**Re: Addendum #1 - Noise Feasibility Study,
 250-256 First Road West, Hamilton, Ontario**

As requested, HGC Engineering has prepared this letter as an addendum to our noise study titled “Noise Feasibility Study, 250-256 First Road West, Hamilton, Ontario” dated April 13, 2020 to reflect the latest site plan dated May 12, 2021, as attached. Refer to the noise study for site description, noise sources, applicable guideline limits, assessment method and warning clauses. The revised analysis and recommendations are summarized below.

DRAWING SHEET TITLE:
SITE PLAN OPTION 2

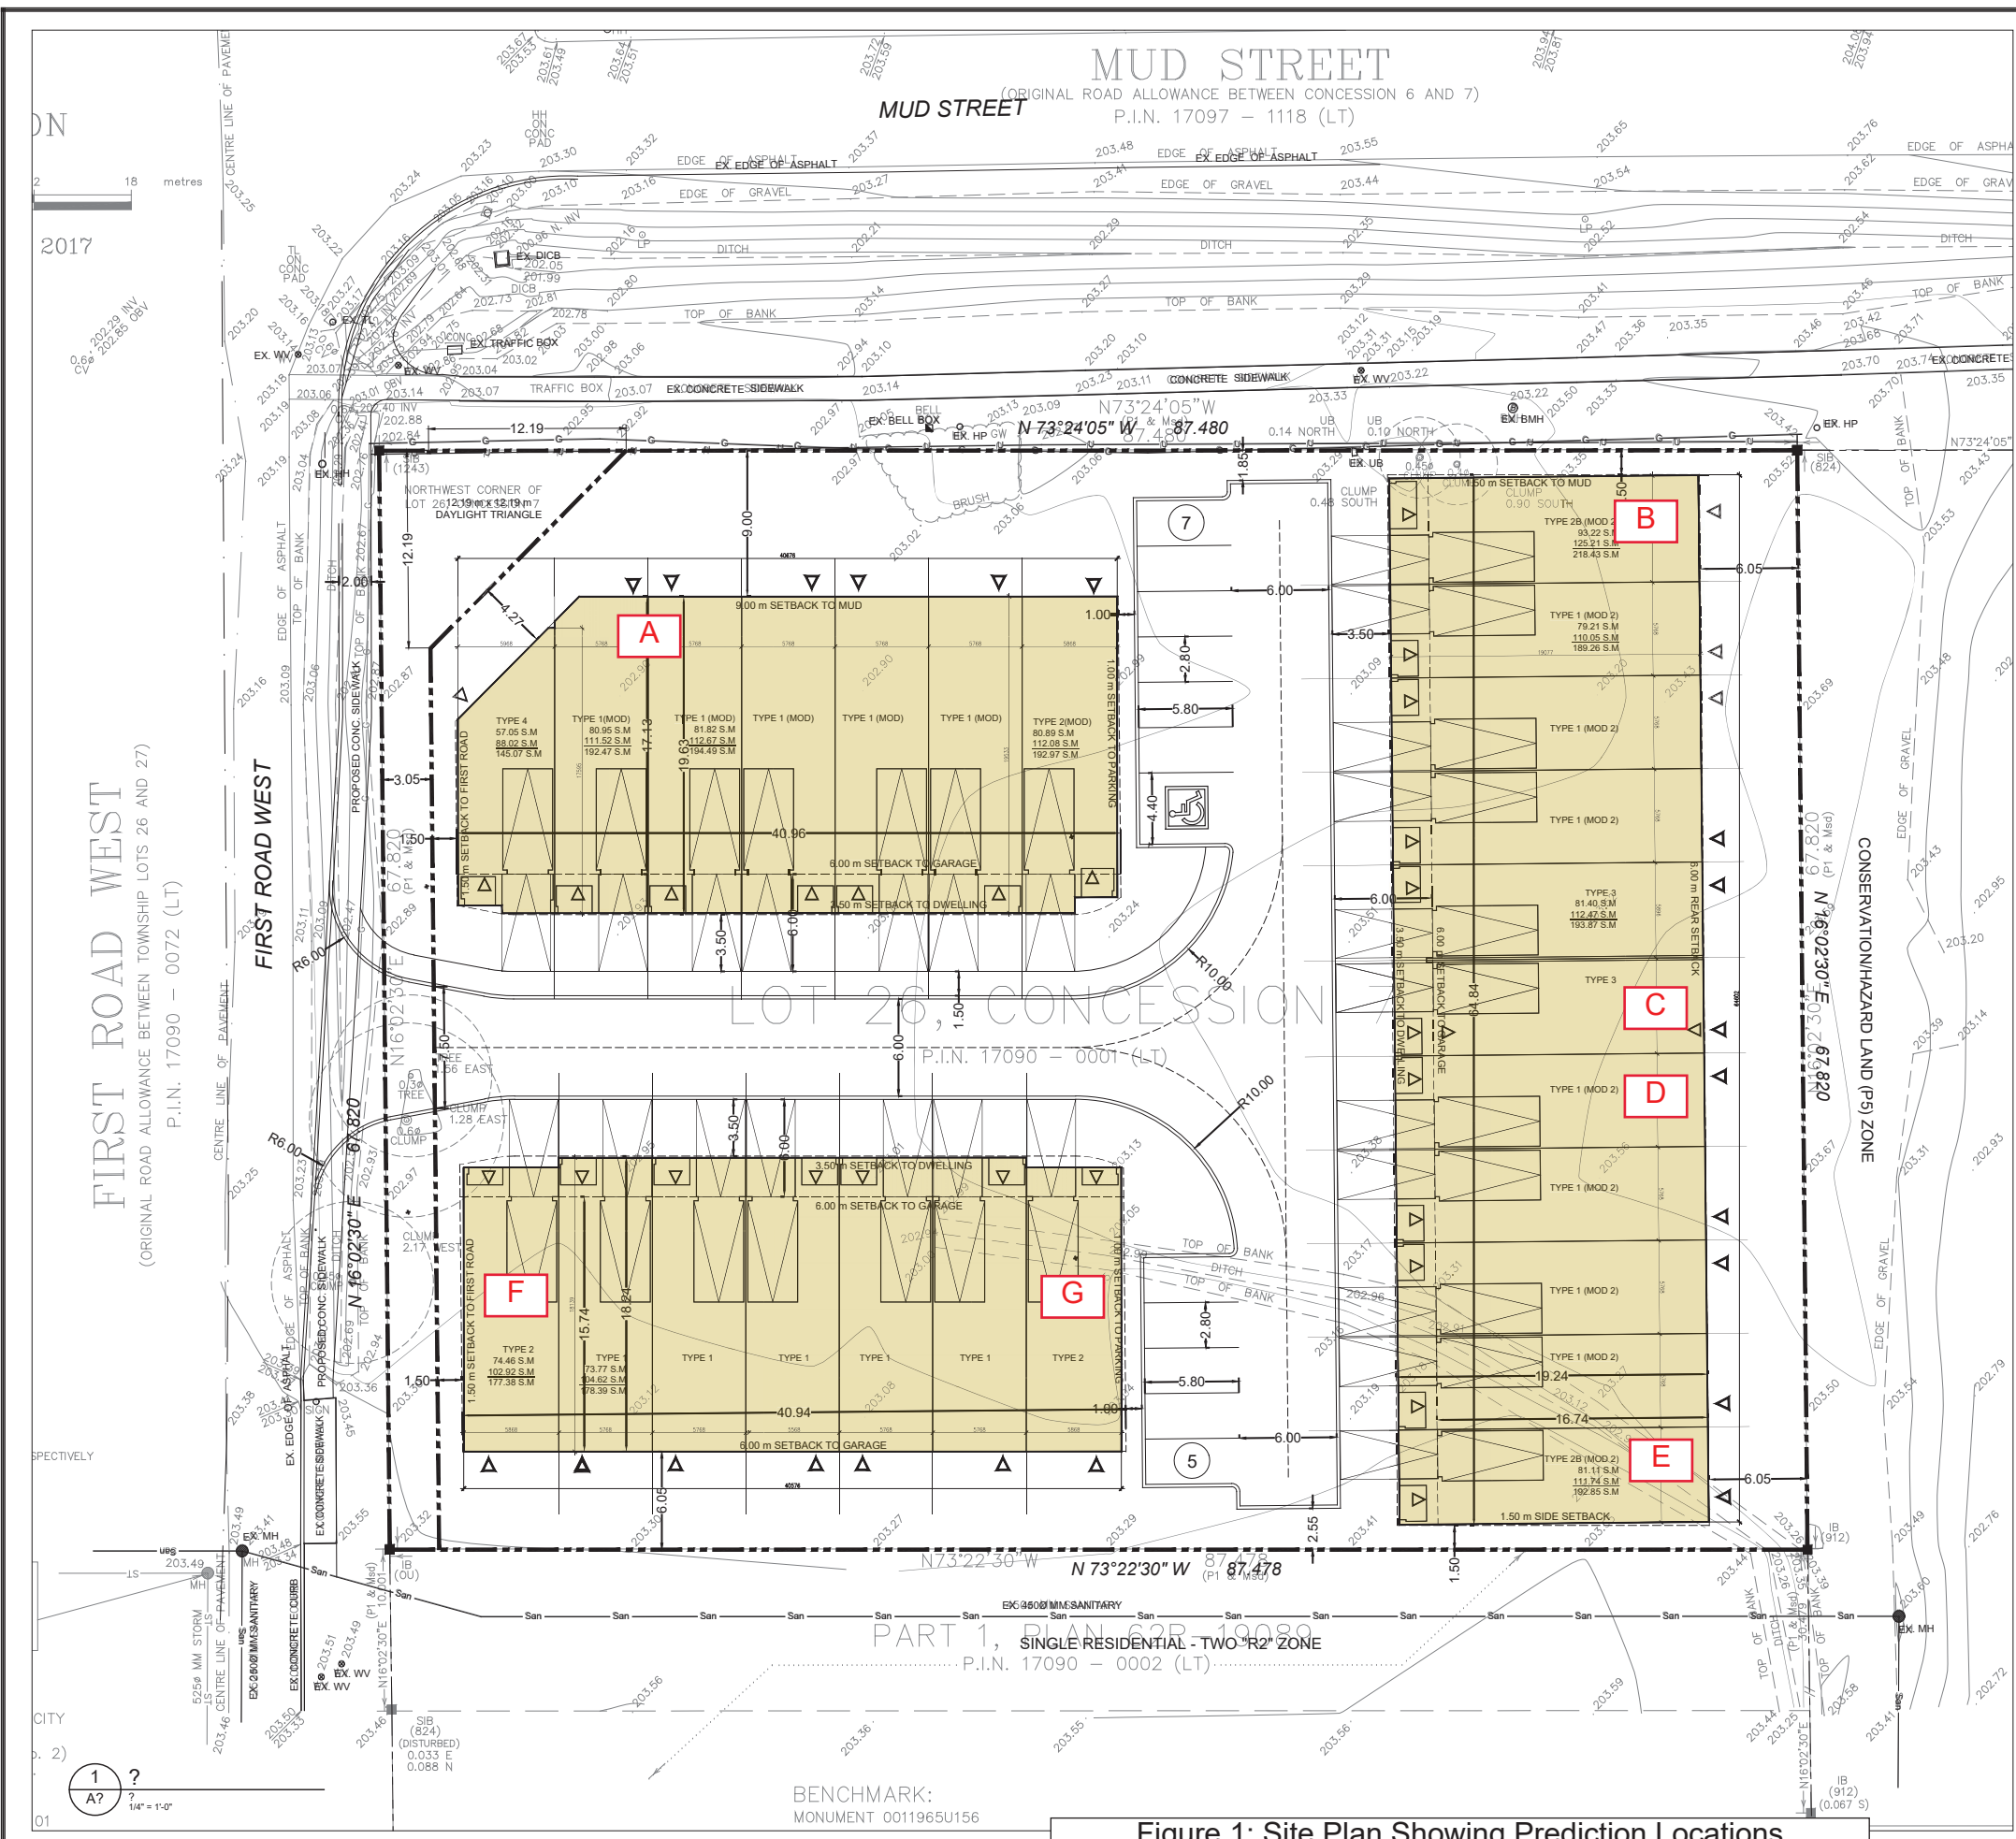
Updated analysis was conducted based on the latest site plan and the results are summarized in Table I. The prediction locations are show on Figure 1.

Prediction Location	Daytime – in OLA, L _{EQ} (16)	Daytime – At Façade, L _{EQ} (16)	Nighttime – At Façade, L _{EQ} (8)
A	65	65	58
B	64	66	59
C	57	58	52
D	55	57	51
E	<55	55	49
F	<55	56	50
G	<55	56	50

Figure 2: Plan Showing Noise Barrier Requirements

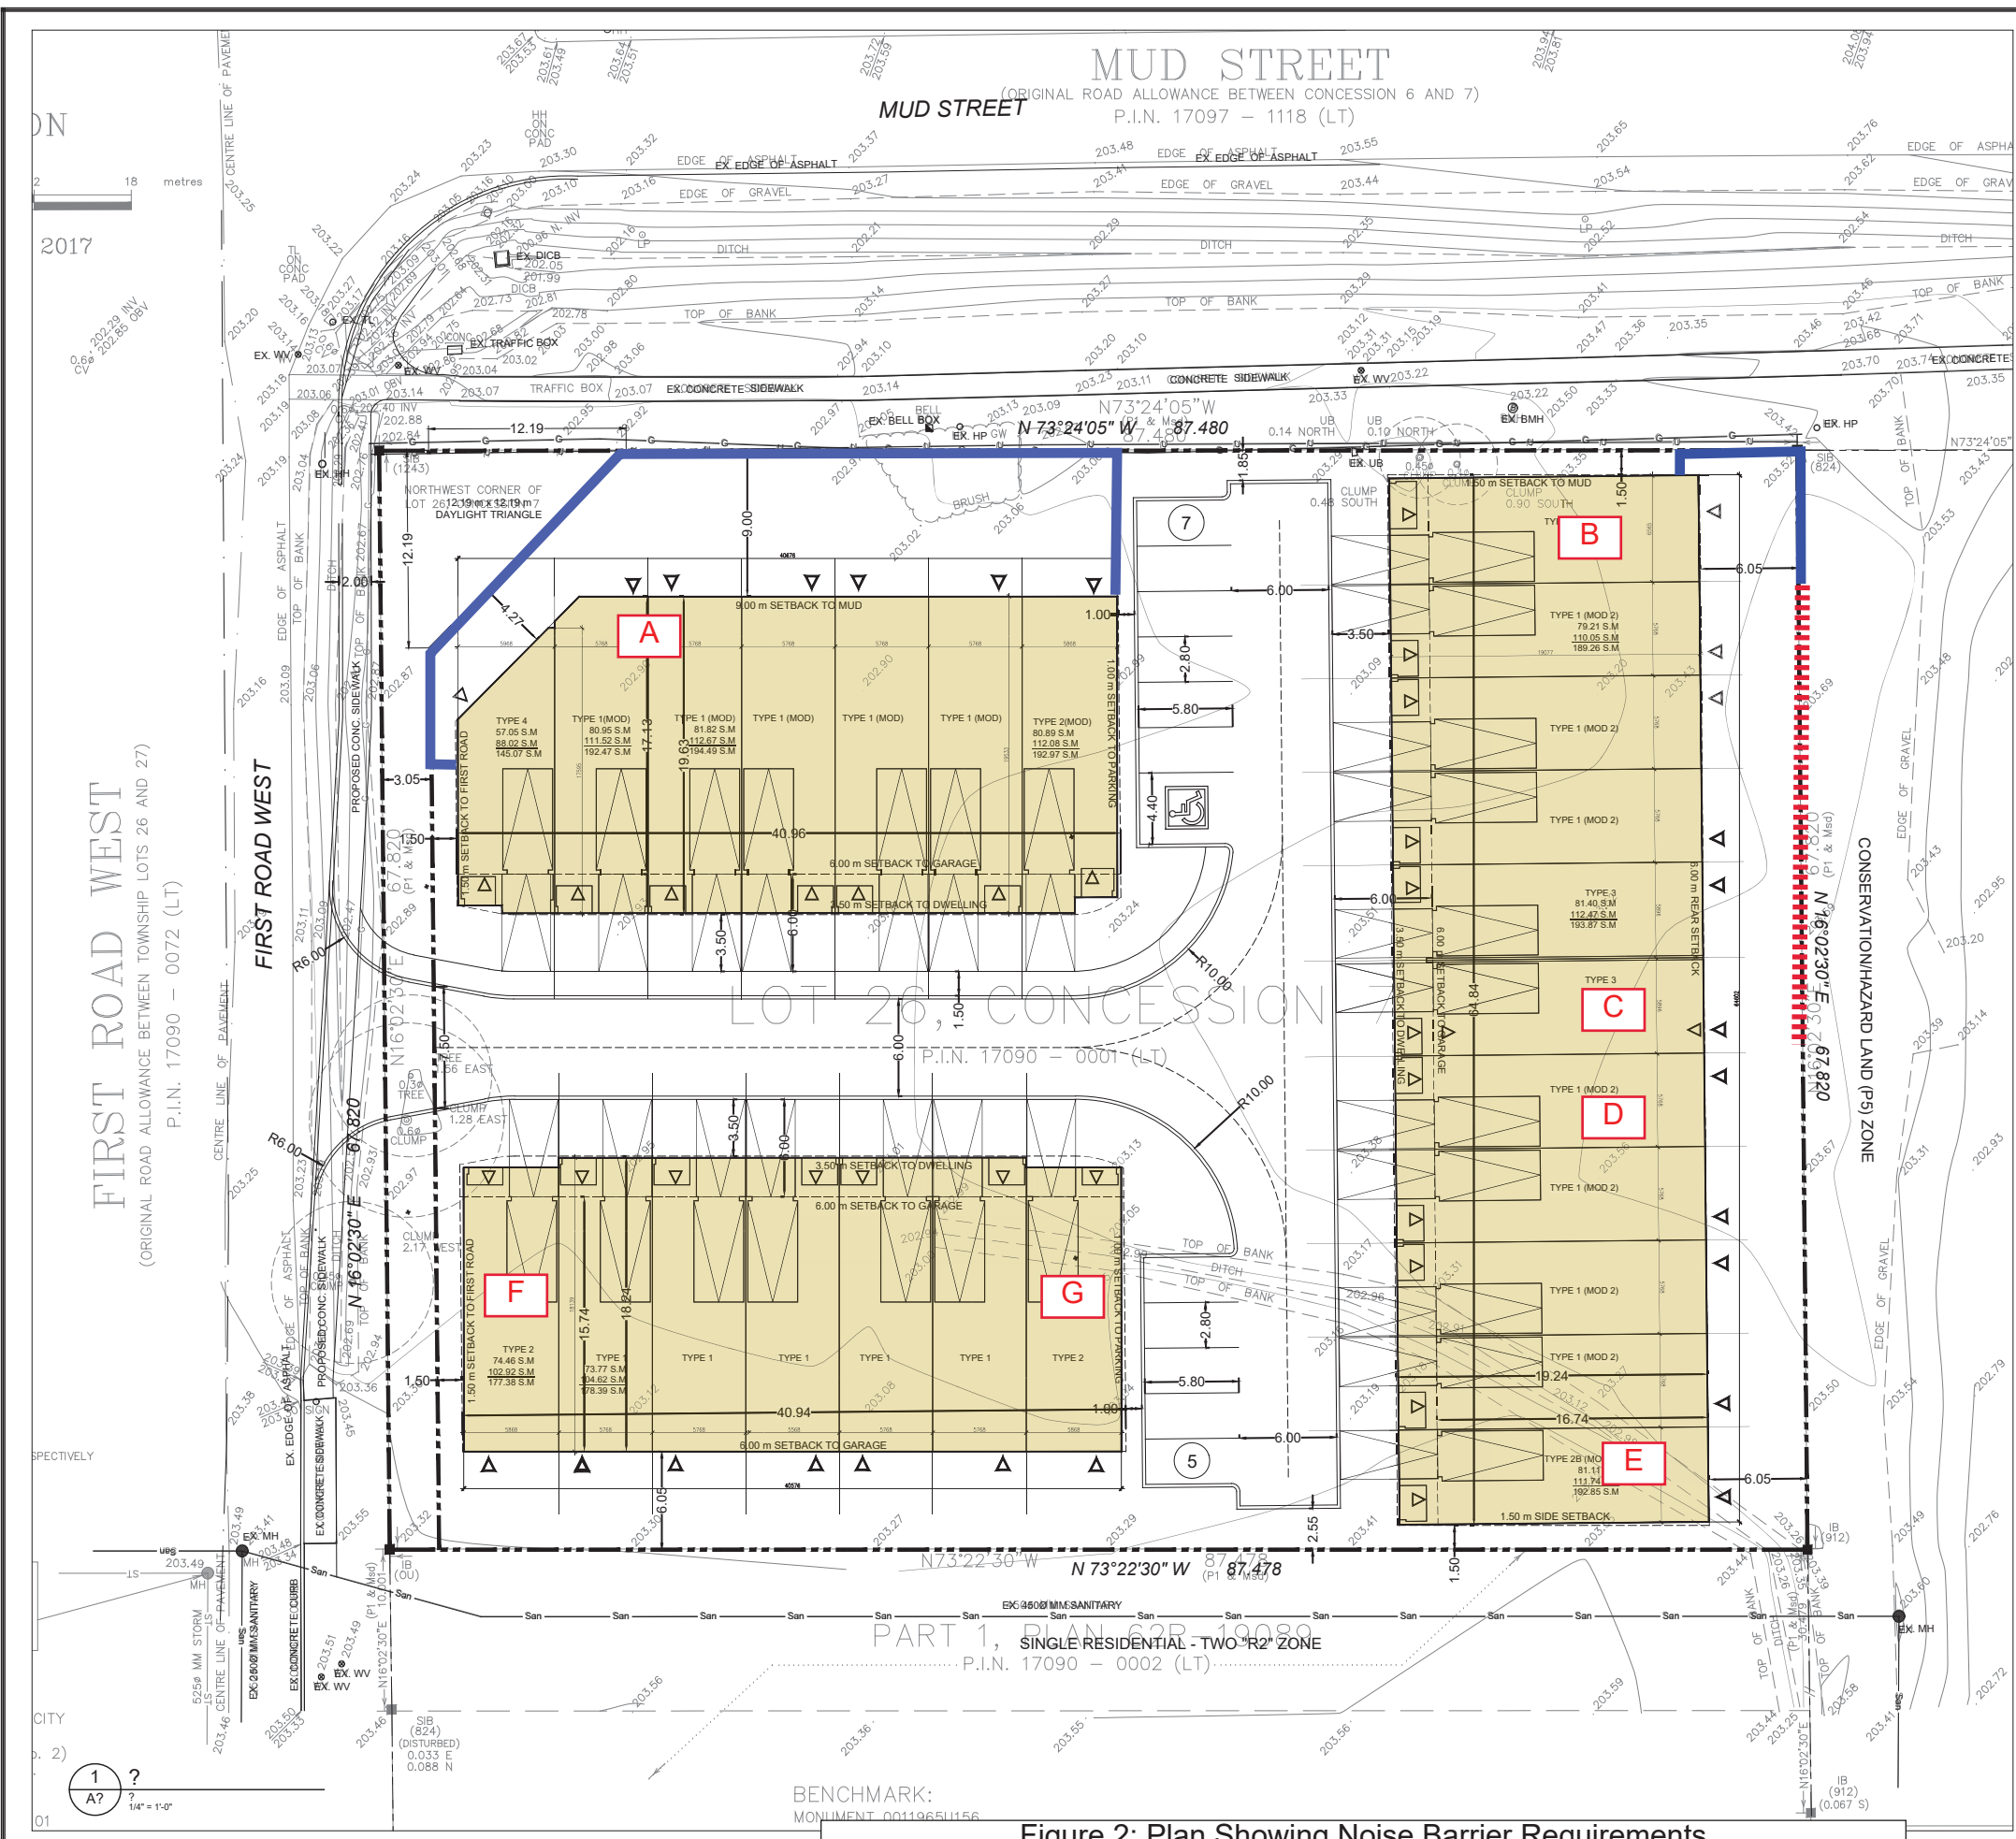
For the two blocks of townhouses adjacent to Mud Street (Locations [A] and [B]), the predicted sound levels in the OLAs will be in the range from 56 dBA to 65 dBA. Noise barriers are required to reduce the sound

levels in the OLAs to less 60 dBA. A table of barrier heights to meet 55, 57, 58 and 59 dBA is provided below.

The location and extent of the acoustical barriers are shown on Figure 2. All noise barriers must return back to the dwelling units so that the rear yards are entirely shielded from the roadway. The acoustic barrier can be a combination of an acoustic wall on top of an earth berm. The wall component of the barrier should be of a solid construction with a surface density of no less than 20 kg/m². The walls may be constructed from a variety of materials such as wood, brick, pre-cast concrete or other concrete/wood composite systems provided that it is free of gaps or cracks.

- Noise Barrier*
- 2.0 m high Noise Barrier

* Noise barrier height as approved by the City of Hamilton
